## Determination 2015/006

### Regarding the code compliance of, and whether consent was required for, a 1.0m high retaining wall adjacent the boundary at 32 Ransom Smyth Drive, Goodwood Heights, Auckland

Figure 1: Section through retaining wall to adjacent property (not to scale)

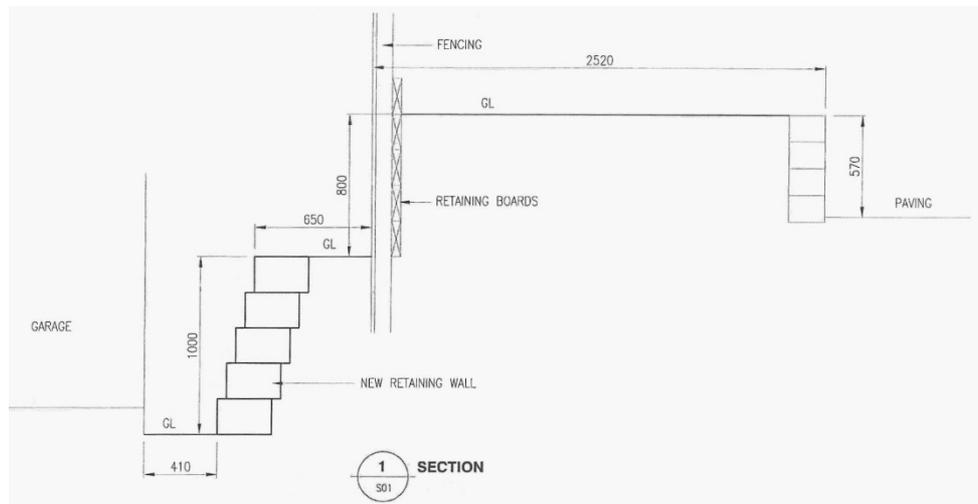
2.1 The development on the subject property required excavation up to approximately 1.0m in the eastern corner of the site along the northeast and southeast boundaries. A keystone-type retaining wall has been constructed within the property at the face of the excavation.

2.2 The height of the retaining wall varies to a maximum of 1.0m and the wall is stepped back approximately 50mm for each 200mm riser. The distance from the back of the retaining wall to the boundary/fence line varies from 350mm to 450mm. Each riser and the blocks are filled with scoria and secured with fibreglass pins.

2.3 The neighbouring site on the southeast boundary is backfilled behind and against the existing wooden boundary fence to a depth of 800mm. Horizontal timbers have been installed along the fence to retain the backfill: the timbers are placed on the neighbour’s side of the fence.

- 5.3 The expert described the construction of the retaining wall and noted that there was no visual evidence that there are any structural issues with the as-built wall. The expert also commented on the backfill behind and against the fence and that the fence posts are leaning towards the subject property as a result of that load. The expert considers the backfill would equate to a surcharge loading in excess of 12.0kPa at the boundary.

- the wall as-built was unlikely to satisfy Clause B1.
- 5.5 The expert concluded that in his opinion the wall should have been designed for a boundary surcharge loading because of the distance from the back of the retaining wall to the boundary in relation to the retaining wall height, and that the wall is already surcharged by fill placed by the neighbour and that surcharge loading would be in excess of 12.0kPa.

- 6.1.2 The expert has observed that the retaining wall is constructed closer to the boundary than was allowed for in the calculations of the applicant's engineer, and that there is an additional surcharge from the backfill on the adjacent property that is likely to be in excess of 12.0kPa. In addition, in discussion with the expert, the applicant's engineer has advised the as-built wall is unlikely to comply with Clause B1.
- 6.1.3 Given the findings of the expert, I conclude that the retaining wall as built does not comply with Clause B1.3.3 of the Building Code in that it does not take account of the earth pressures resulting from the positioning of the wall in relation to the boundary and the ground level of the adjacent property.

- 6.2.3 Although the retaining wall is less than 1.5m in height, it has been located in a position where there is a surcharge additional to the load of the ground i.e. the raised ground level of the adjacent property.
- 6.2.4 Accordingly I am of the view that the retaining wall should not have been built without consent, and that the authority was correct in the exercise of its powers of decision in requiring the building consent be amended to include the retaining wall.

- 7.1 It is now for the applicant to bring the retaining wall into compliance with the Building Code. I suggest that the applicant engage the services of an appropriately qualified person to evaluate the as-built structure and develop a proposal of the building work required to make the retaining wall compliant. That proposal should then be put to the authority for its approval.
- 7.2 The consultant has issued a directive that appears to the applicant to be a 'stop work' notice. I see no reason why other work unrelated to the retaining wall and associated sitework or immediately associated with the wall, cannot continue while issues associated with the retaining wall are resolved.
- 7.3 The authority retains the option of issuing a notice to fix should no action be taken in bringing the retaining wall into compliance with the Building Code.

- the as-built retaining wall does not comply with Clause B1.3.3(d) of the Building Code, and
- the exercise of the authority's powers of decision in requiring the building consent be amended to include the retaining wall is correct; and accordingly I confirm that decision.
